HISTORIC LANDMARK COMMISSION  
STAFF REPORT

TRACY AVIARY WILSON PAVILION  
RENOVATION, SOUTHERN GROUND  
HORNBILL'S NEW CONSTRUCTION,  
INSTALLATION OF TEMPORARY BUILDING,  
ACCEPT MASTER PLAN  
Major Alterations and New Construction &  
PLNHLC2008-00684  
Liberty Park, 589 East 1300 South  
August 5, 2009

**SOUTHERN GROUND HORN BILLS**  
**HOLDING BUILDING**  
Tracy Aviary, Salt Lake City, Utah

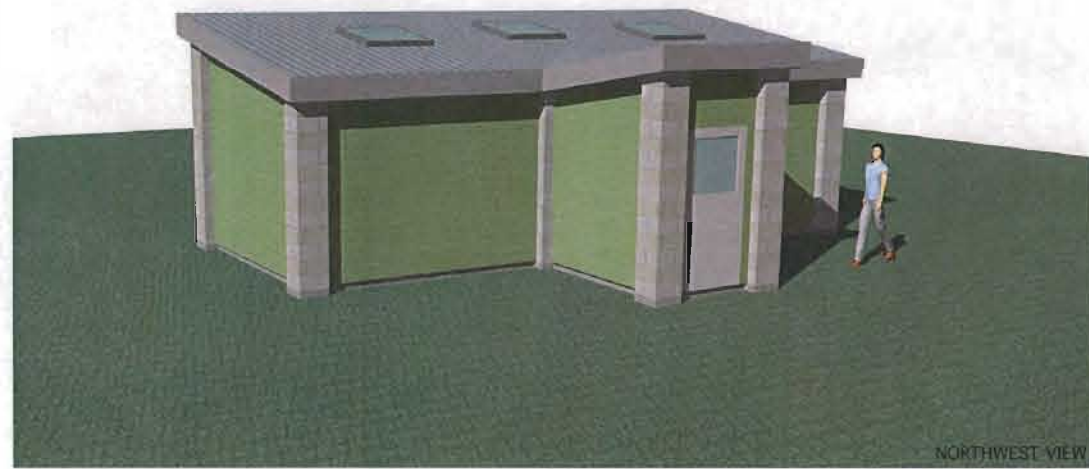
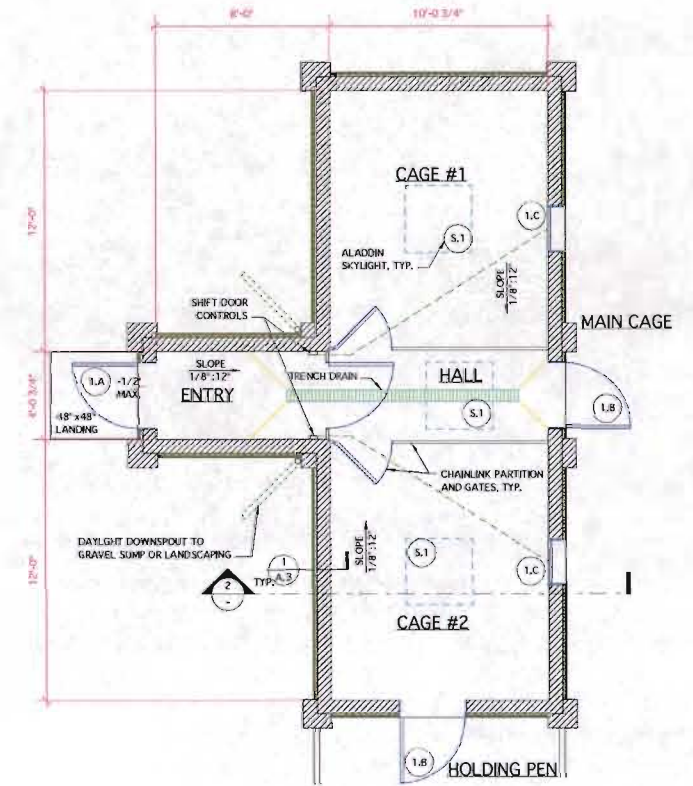
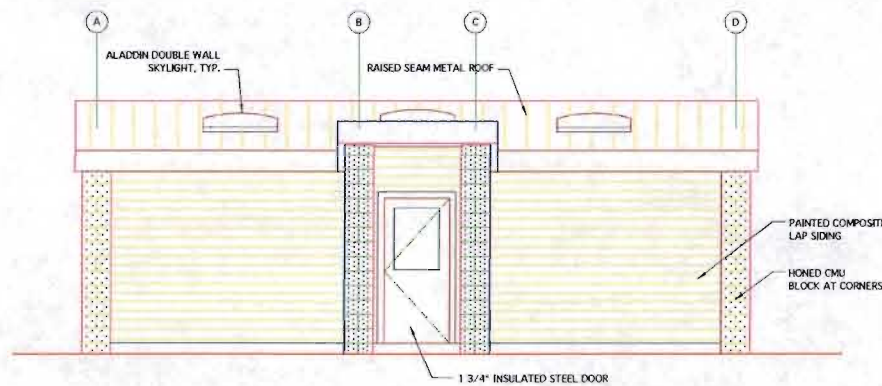
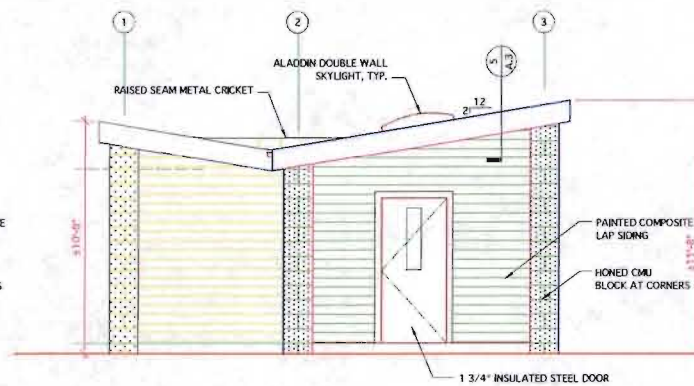
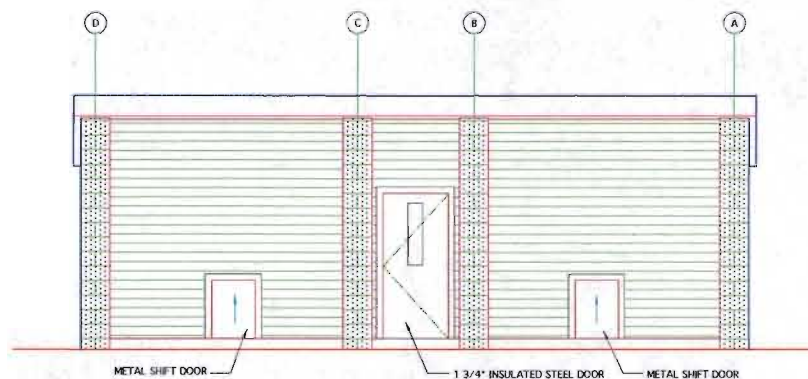
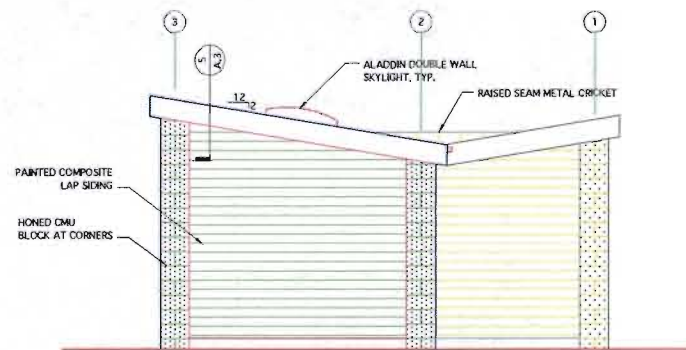
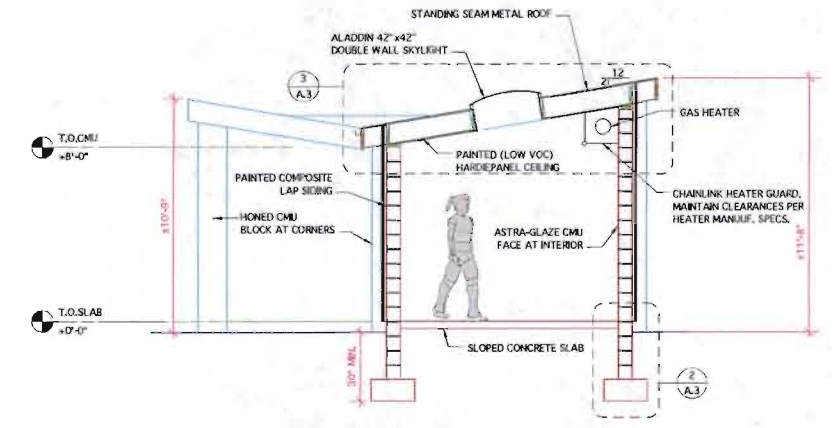
**Finding:** The scale and form of historic structures within the park vary greatly depending on their function. The proposed structure will be among the smaller scaled buildings in the park. In terms of height, width, and square footage it will be similar in scale to nearby structures, and smaller in scale than some historic structures of the park and similar to comparable interactive exhibits in the Aviary. The double shed roof is compatible with other recent construction in the Aviary. The building is compatible in height, width, proportion scale, massing and roof shape and so meets this standard.

**Finding:** The proportions of openings and rhythm of solids to voids in the façade is compatible with existing structures. The proposed building does not have a porch; however none of the buildings within the Aviary have porches. The materials-- honed CMU, composite lap siding, and metal roofing--are in keeping with other buildings and exhibits in the Aviary. The project meets this standard.
